Mr. Ryan Safty  
Community Development Department  
Town of Los Gatos  
110 E. Main Street  
Los Gatos, CA 95031

**RE: 16890 Roberts Road**

I reviewed the drawings, and evaluated the site context. I have reviewed many homes nearby including all of the structures in the Laurel Mews project and along Mitchell Avenue. My comments and recommendations are as follows:

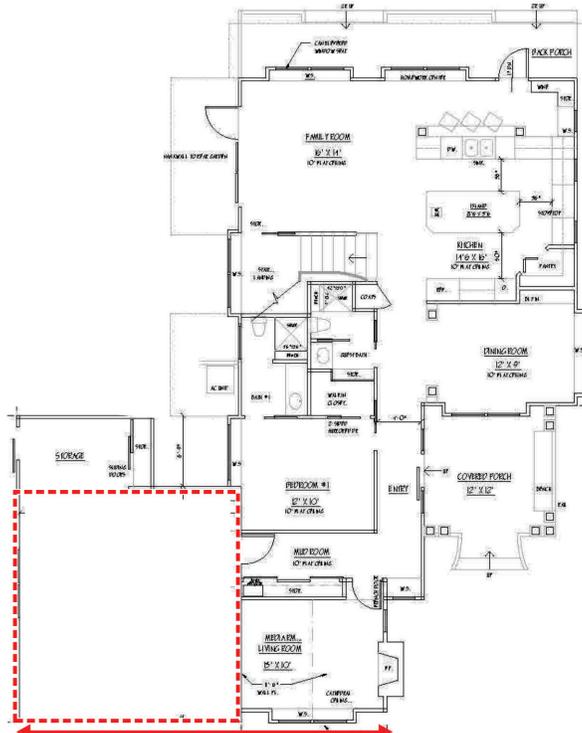
1. The proposed garage is located at the front of the house and is flush with the house facade while the primary neighborhood garage locations along George Street is at the rear of the lot, minimizing the visual impact of garage doors on the streetscape and discouraging cars parked within the front setback. This garage location is not consistent with Residential Design Guidelines 2.4.1 and 3.4.1.

Garage flush with main facade is not consistent with Residential Design Guidelines 2.4.1 and 3.4.1

1. Set the garage back substantially from the front facade of the house. The setback should be deep enough to allow cars to park on the driveway without projecting into the front setback.

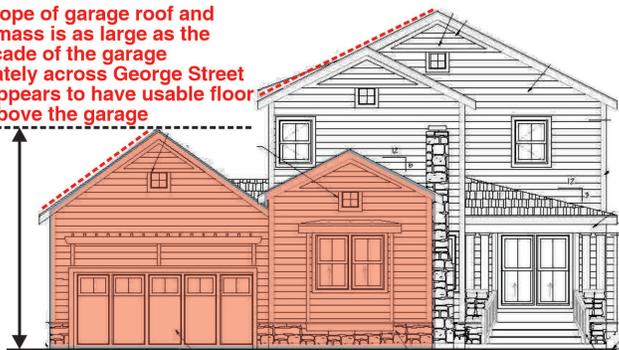
Steep slope of garage roof and garage mass is as large as the front facade of the garage immediately across George Street which appears to have usable floor space above the garage

Garage flush with front of the house is not consistent with Residential Design Guidelines 2.4.1 and 3.4.1

**Project as proposed**  
Building height is much taller  
Garage facade is very tall

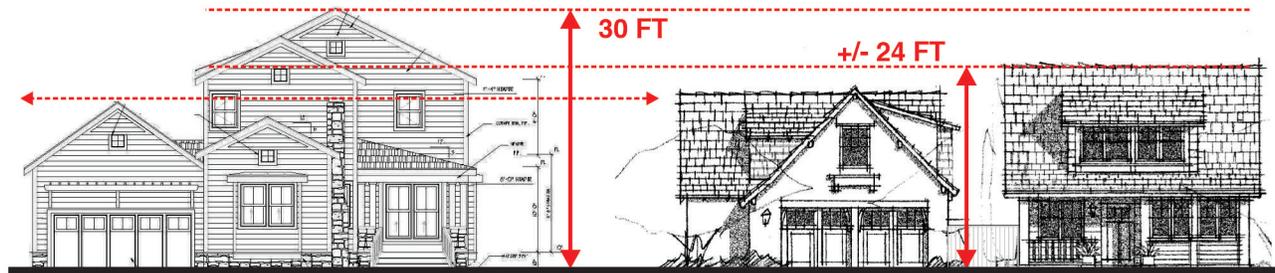
- The proposed height of the house is much greater than other nearby homes, and would not be consistent with Residential Design Guideline 3.3.2.

2. Lower the roof slope on the garage to match the other main roof slopes.
3. Work with the applicant to reduce the height of the house to be more compatible with other homes along George Street, and unify roof pitches. A significant height reduction should be expected. The existing ceiling heights and roof slopes are shown in the illustration below.

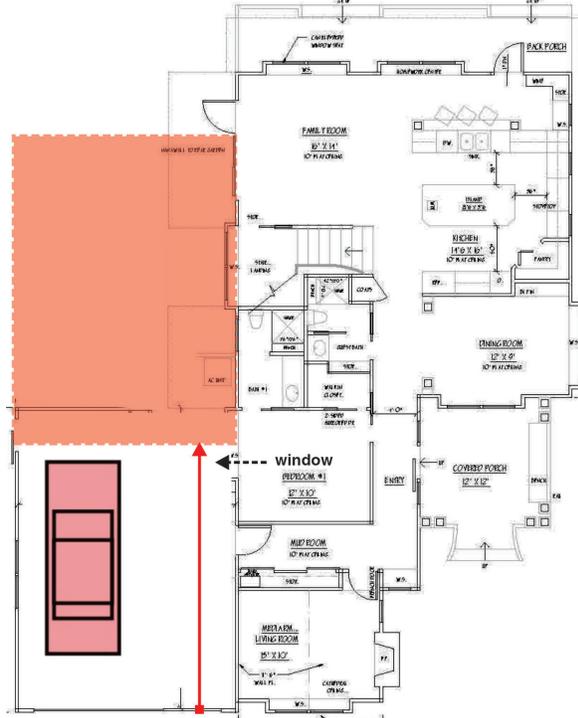
Also, the garage facade is as high and wide as the street facade of the house immediately across George Street.

**Steep slope of garage roof and garage mass is as large as the front facade of the garage immediately across George Street which appears to have usable floor space above the garage**

**Garage flush with front of the house is not consistent with Residential Design Guidelines 2.4.1 and 3.4.1**

- The garage roof would have a much steeper slope than the main roofs of the house which would not be consistent with Residential Design Guideline 3.5.1. While garage on the home immediately across George Street has a similar steep-sloped roof, it appears to have living space located above the garage which is not the case with this proposed hoouse.

**Height Reduction Technique #1**

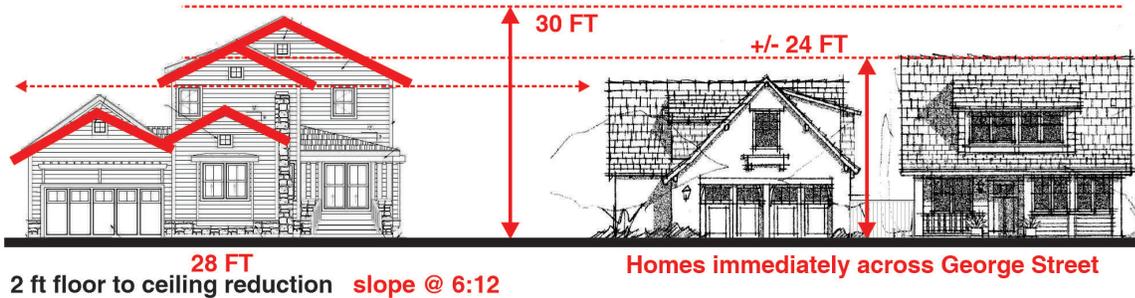
**30 FT**  
Project as proposed slope @ 6:12

**+/- 24 FT**  
Homes immediately across George Street

Reduce the floor-to-ceiling heights on both the first and second floors. The currently proposed ceiling heights are 10 feet on the first floor and 9 feet on the second floor. This is in contrast to the Laurel Mews homes across George Street which are 9'-1" and 8'-1" respectively. Also shown on the illustration below, the roof over the garage, which has a slope greater than the main structure, has been reduced to match the lower main house slope.
